Midway City Council
7 December 2021
Regular Meeting

Mill Canyon Farms Subdivision /
Final Approval

CITY COUNCIL MEETING STAFF REPORT

Subject: Mill Canyon Farms – Final Review

MILL CANYON FARMS PLAT - 22 OCTOBER 2021

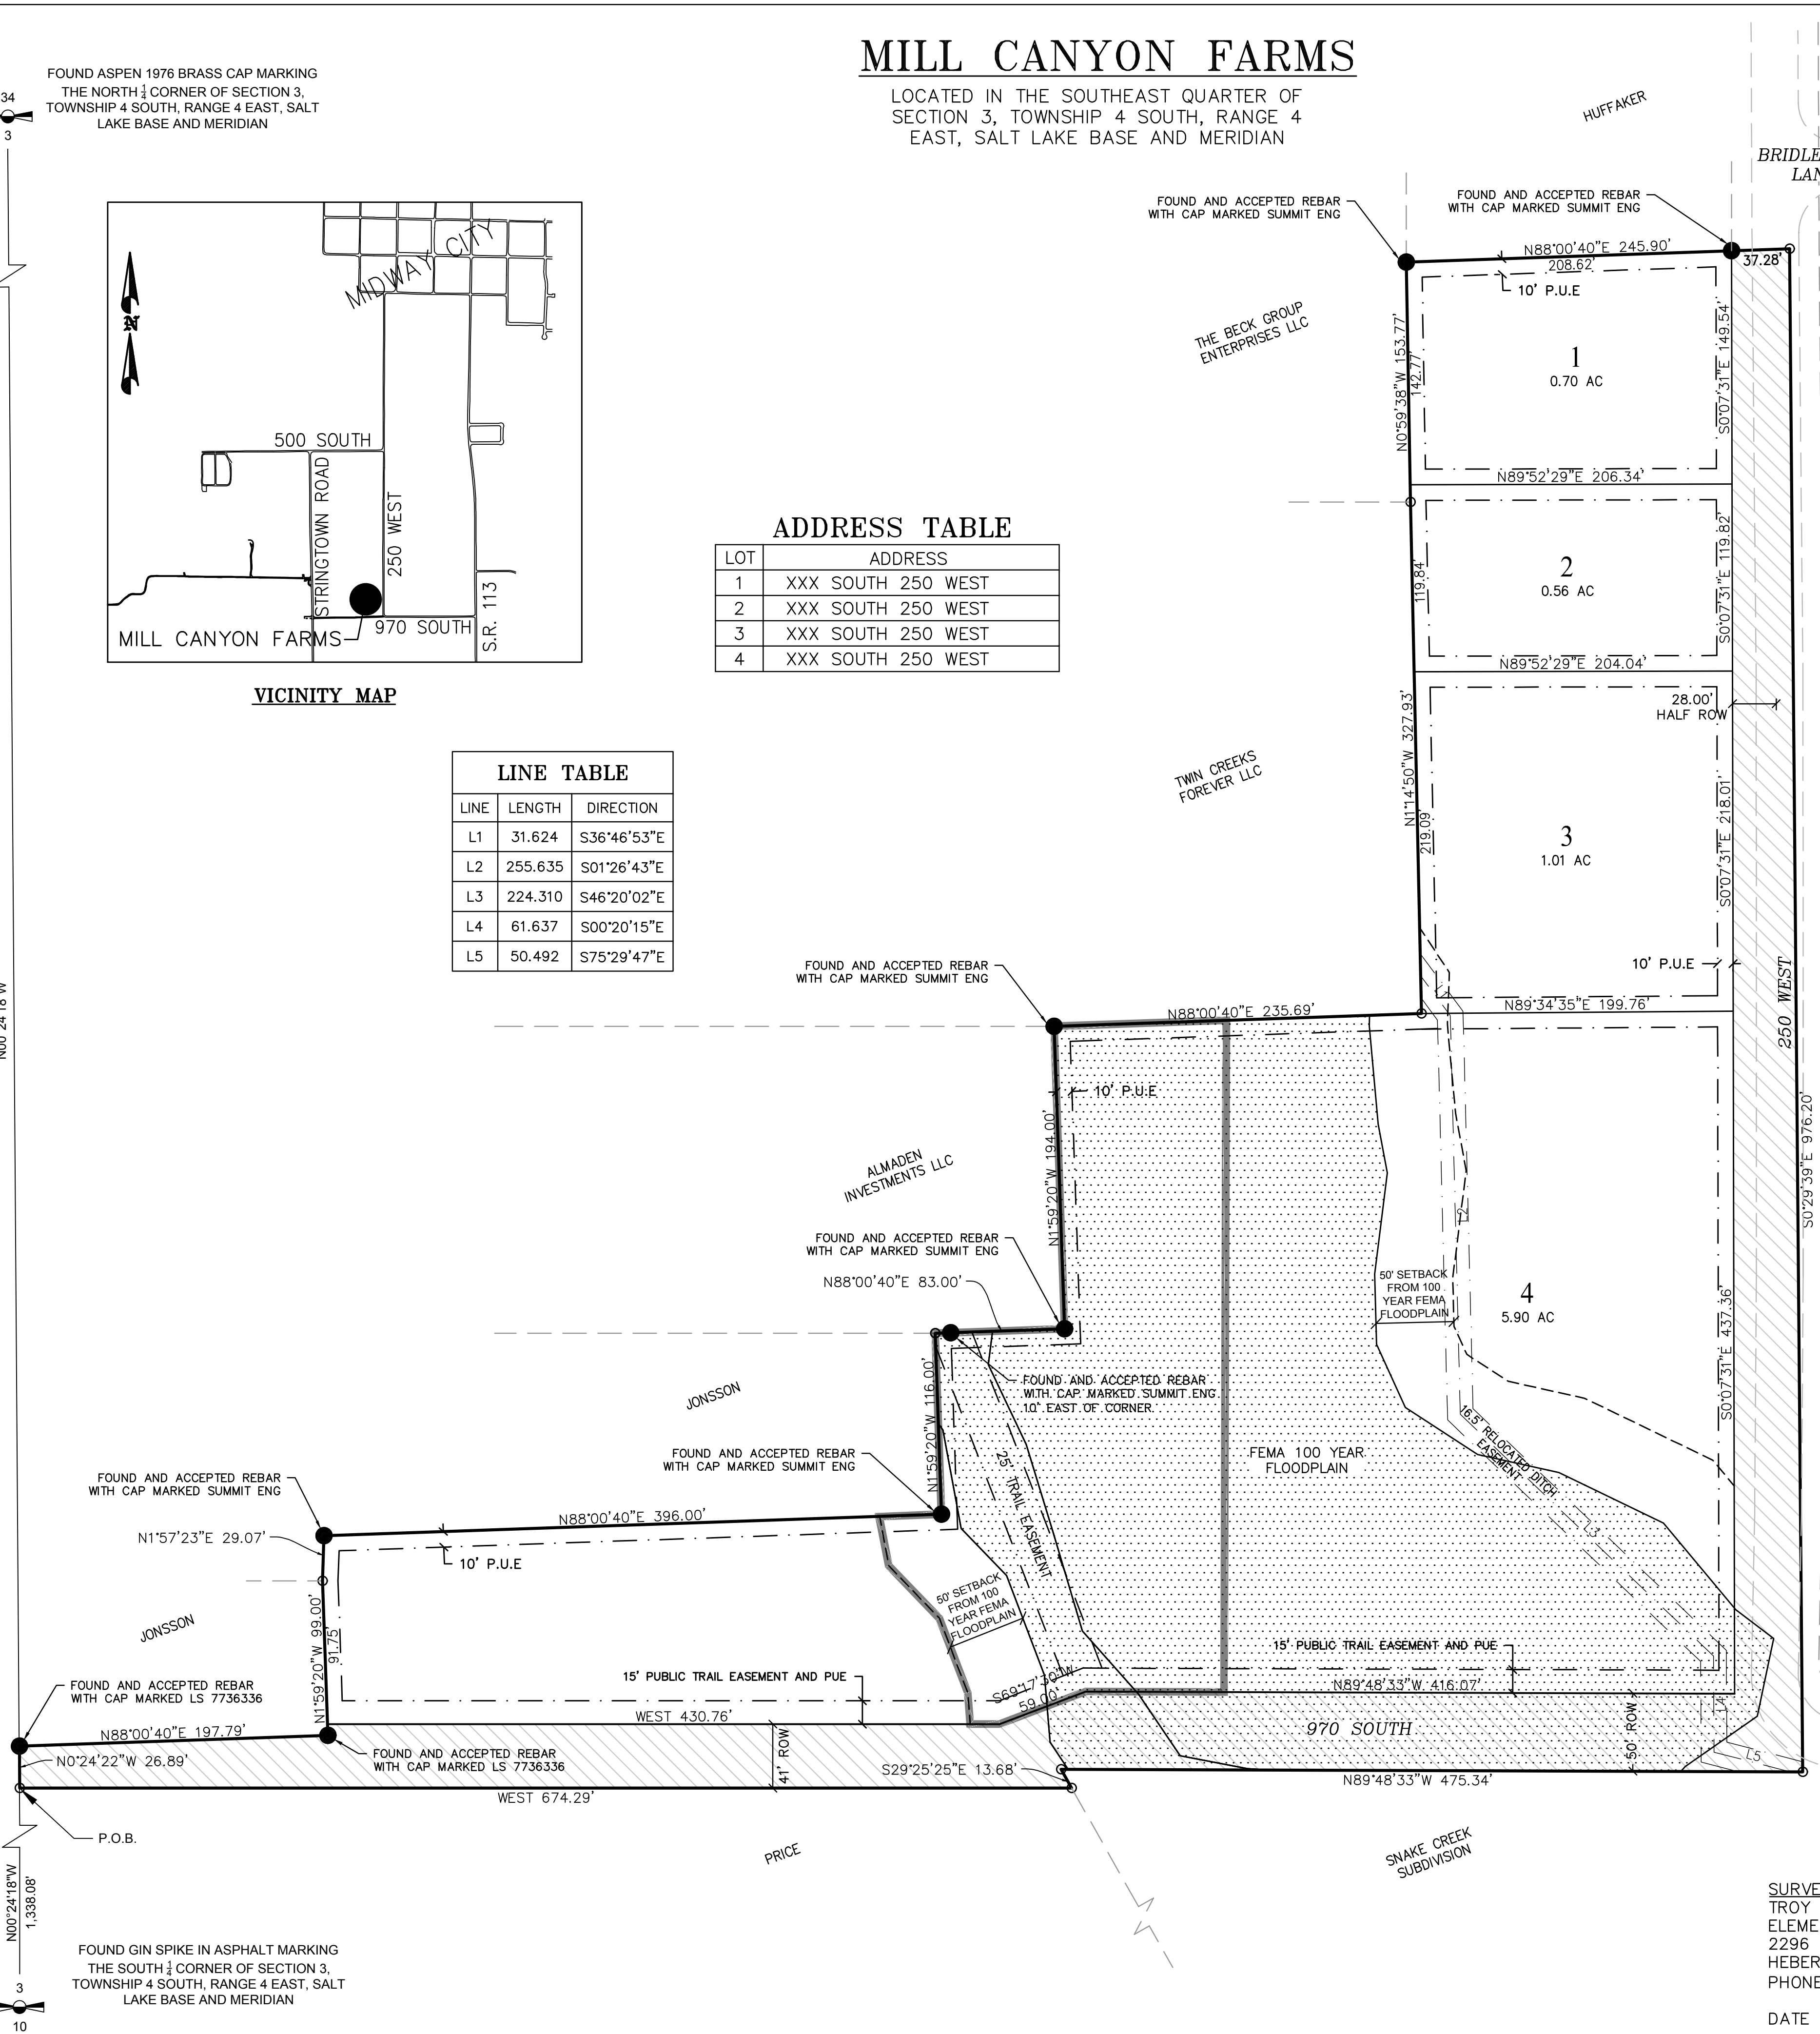
The portion of the lot that counts towards the required open space obligation needs to be clearly identified on the plat along with a note stating that the open space is unbuildable and clarifying what uses can occur on the open space.

- The proposed lot 4 within the development is within a designated FEMA flood plain. A 50' setbacks shall be maintained around all FEMA flood Zones.
